Addendum
to the
U.S. 50/Ponderosa Road/South Shingle Road
Interchange Improvements Project
Initial Study/Mitigated Negative Declaration
(SCH #2018012042)

El Dorado County
Department of Transportation
2850 Fairlane Court
Placerville, CA 95667

March 2025

Proposed Addendum

Section 2.1.1.2 Parking

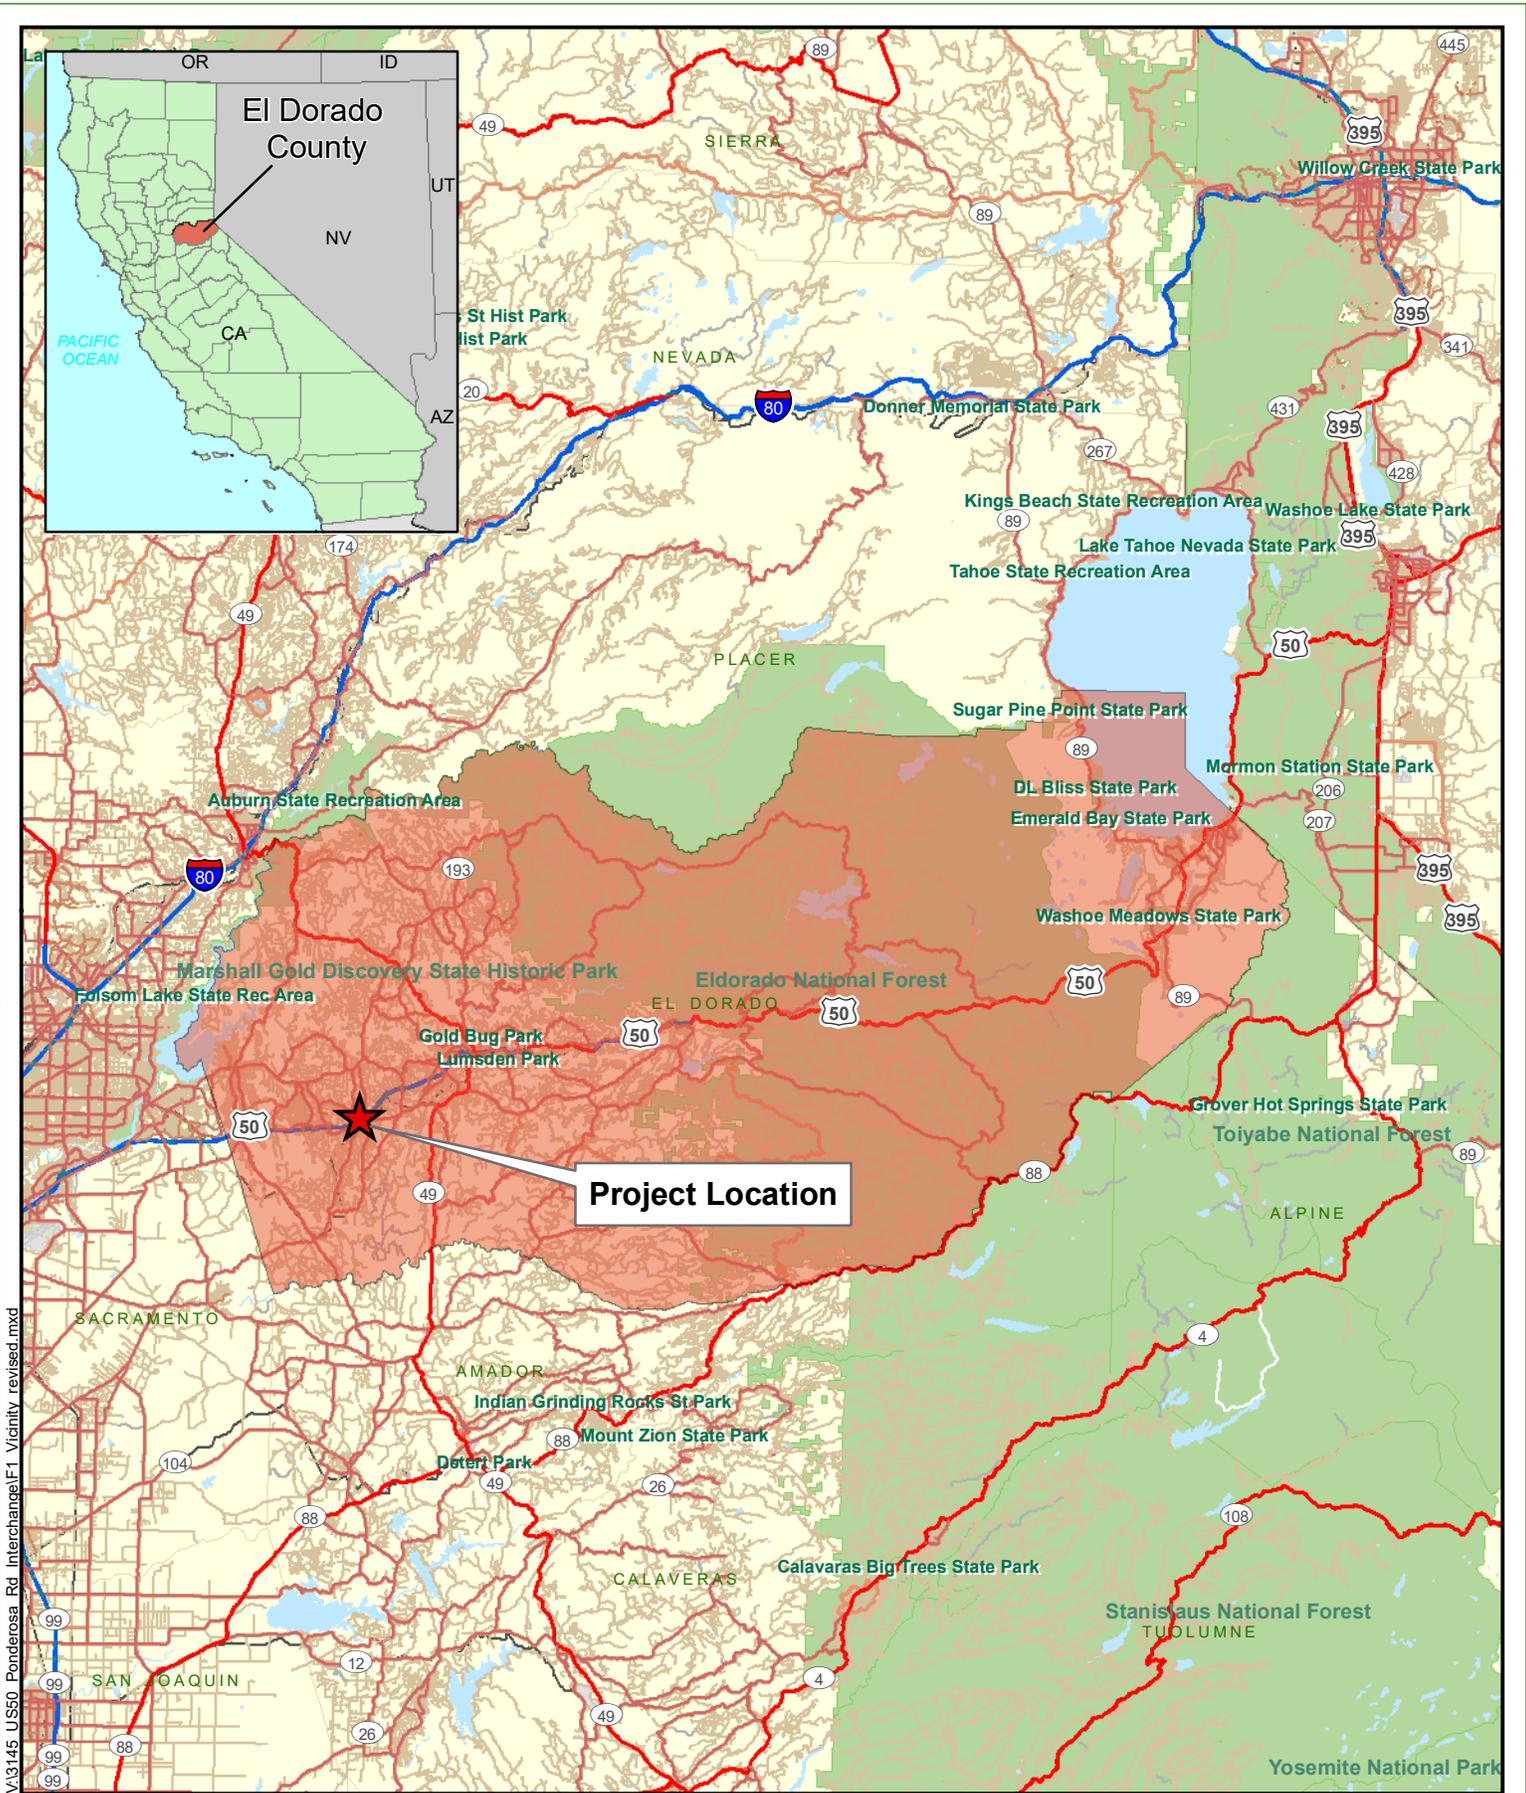
Lastly, pursuant to the 2023 El Dorado Transit Park-and-Ride Master Plan, the number of parking spaces in the northwest (Wild Chapparal), northeast (North Shingle Road), and southwest (Durock Road) parking lots has changed. The following revisions to Section 2.1.1.2 Parking has been updated to reflect the accurate number of spaces to be removed and replaced as a result of the proposed Project (Build Alternative 1):

Currently there are three park and ride facilities in the project area, located in the northwest, northeast, and southwest quadrants. The northwest lot has ~~413~~ 94 spaces, the northeast lot has ~~28~~ 18 spaces, and the southwest lot has ~~60~~ 44 spaces. Under Build Alternatives 1 and 2, improvements to the interchange on- and off-ramps and the realignment of North Shingle Road would eliminate the park and ride lot in the northeast quadrant which will result in a loss of ~~28~~ 18 parking spaces. Replacement spaces have been incorporated into the project design by adding ~~28~~ 18 spaces to the park and ride lot in the southwest quadrant. As a result, Build Alternatives 1 and 2 would not reduce the number of park and ride parking spaces in the project area.

Figure 3
Project Features

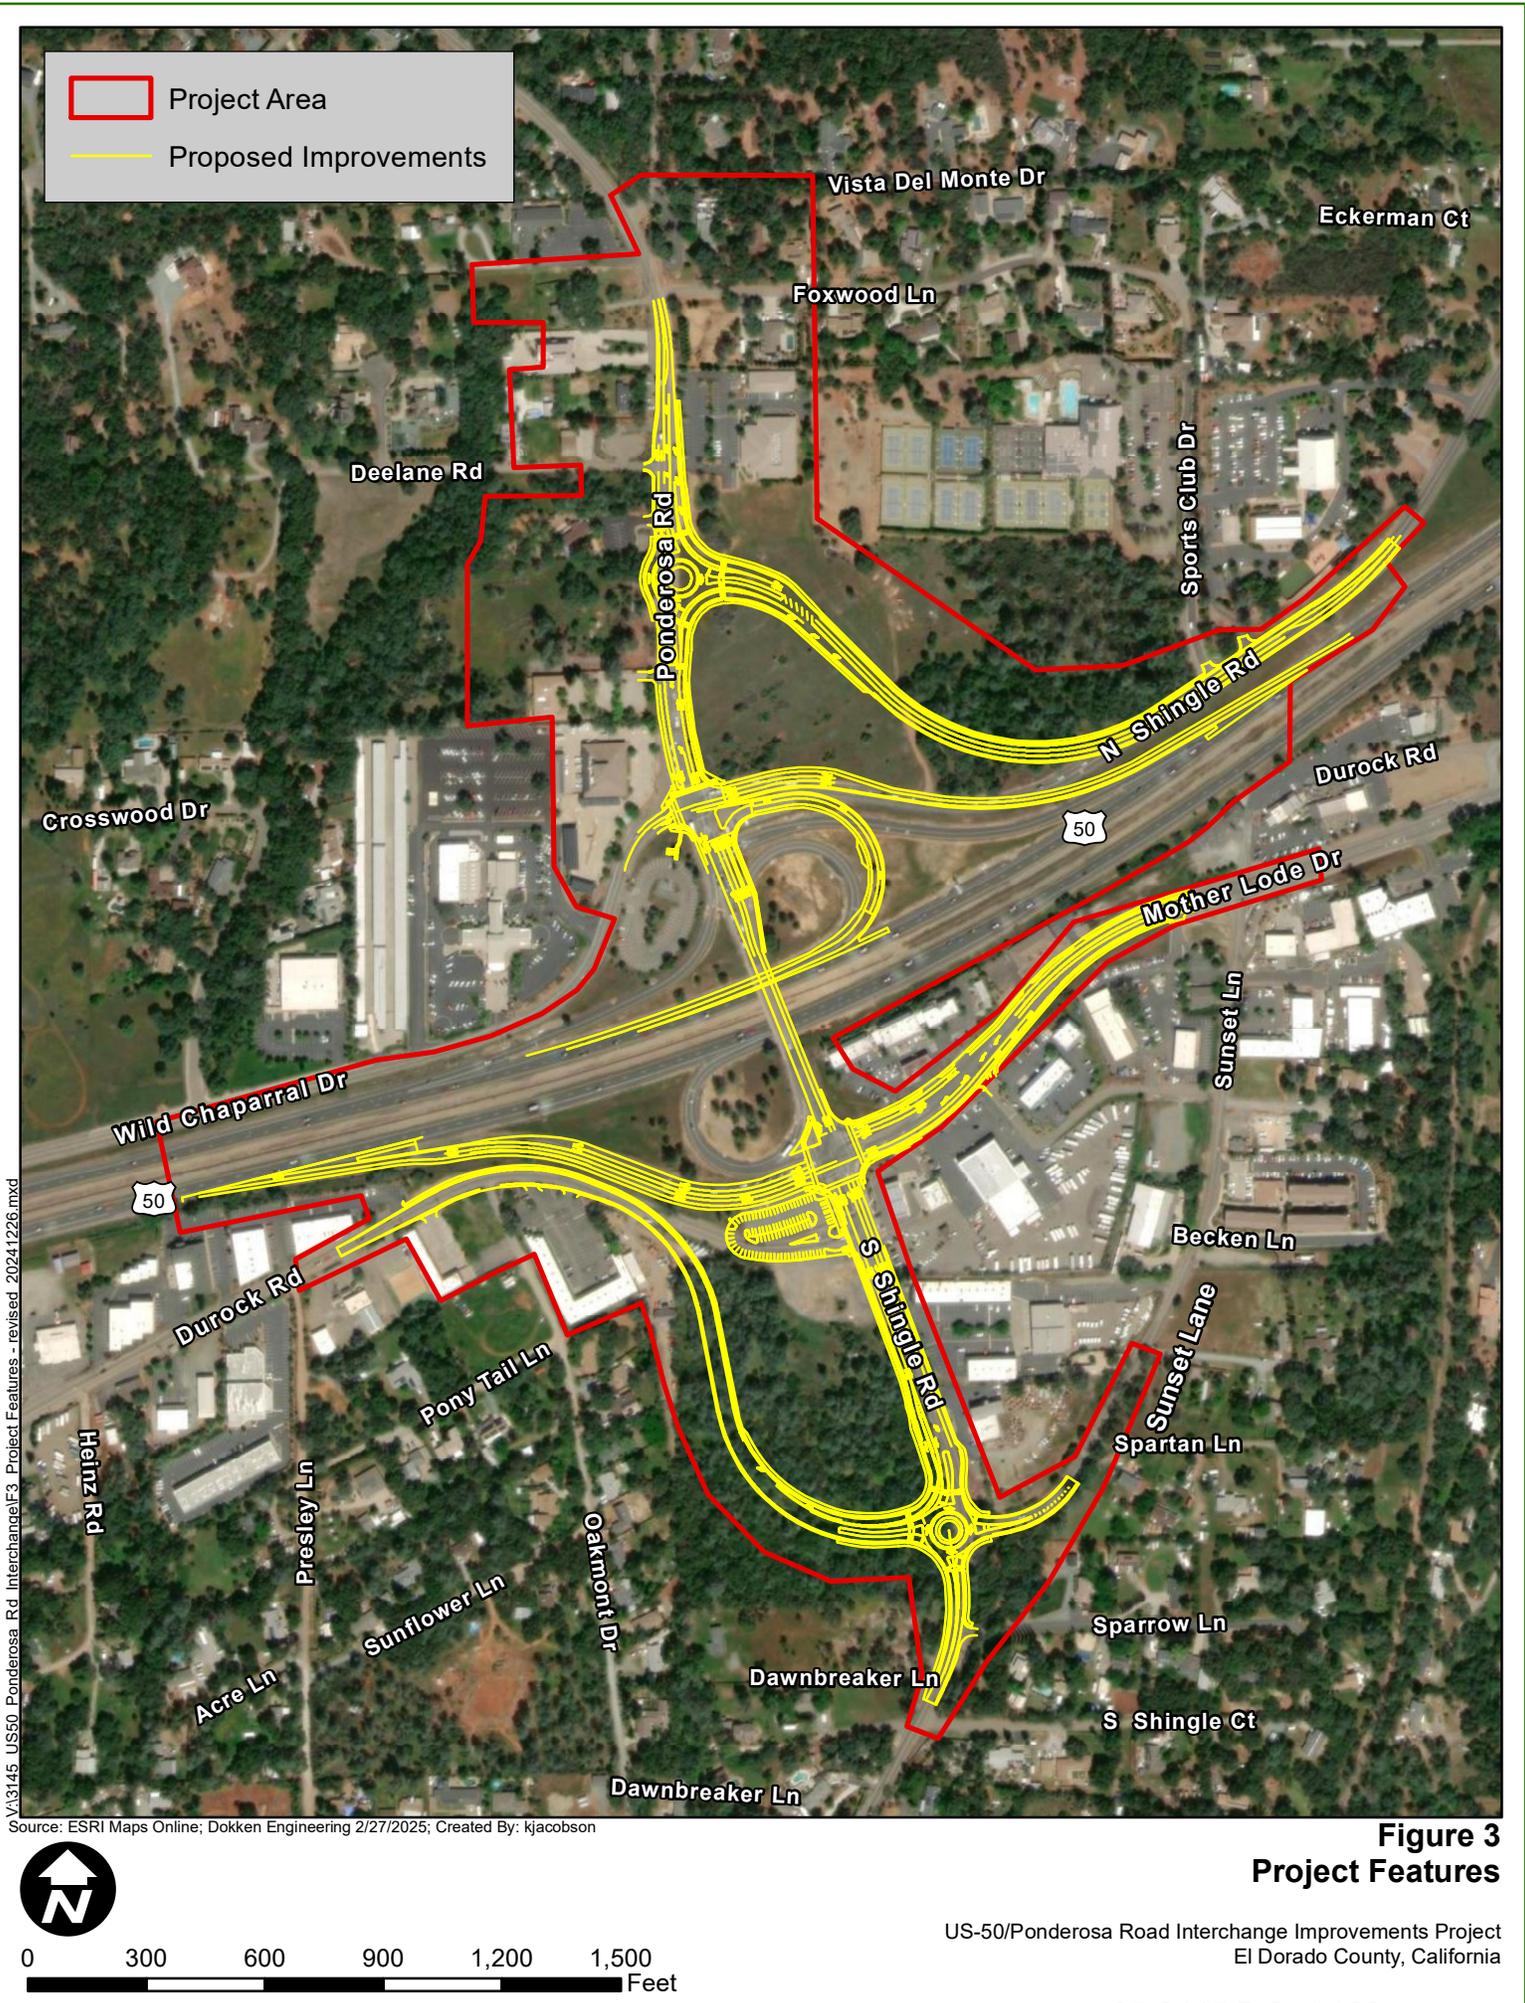
This Addendum proposes to amend the project features exhibit of the final Initial Study/Mitigated Negative Declaration (IS/MND) document to include the construction of roundabouts at the intersection of Ponderosa Road and North Shingle Road, and the at the intersection of South Shingle Road with Durock Road and Sunset Lane. Based on further traffic and air quality analysis since approval of the 2020 IS/MND, it was determined that roundabouts perform better operationally than the previously approved signalized intersection design by reducing traffic congestion and thereby pollution due to less idling (see Sections III Air Quality and XVI Transportation). Roundabouts were also selected for public safety purposes. Studies show that roundabouts significantly reduce severe crashes with up to a 40% reduction in total crashes and a 76% reduction in crashes resulting in injuries or fatalities by having fewer vehicle to vehicle and vehicle to pedestrian conflict points¹. A five-year collision history for the Ponderosa Road/South Shingle Road corridor showed 13 injury-related collisions. Including roundabouts as a design feature is anticipated to reduce the number of vehicle and pedestrian/bicycle accidents at the intersection of Ponderosa Road and North Shingle Road, and the at the intersection of South Shingle Road with Durock Road and Sunset Lane.

Discussion: The change to include roundabouts instead of signalized intersections is not considered a major revision to this Project. As demonstrated in the attached CEQA Checklist, no new significant environmental effects or increase in the severity of previously identified effects will occur as a result of this addendum to include roundabouts as a design feature.
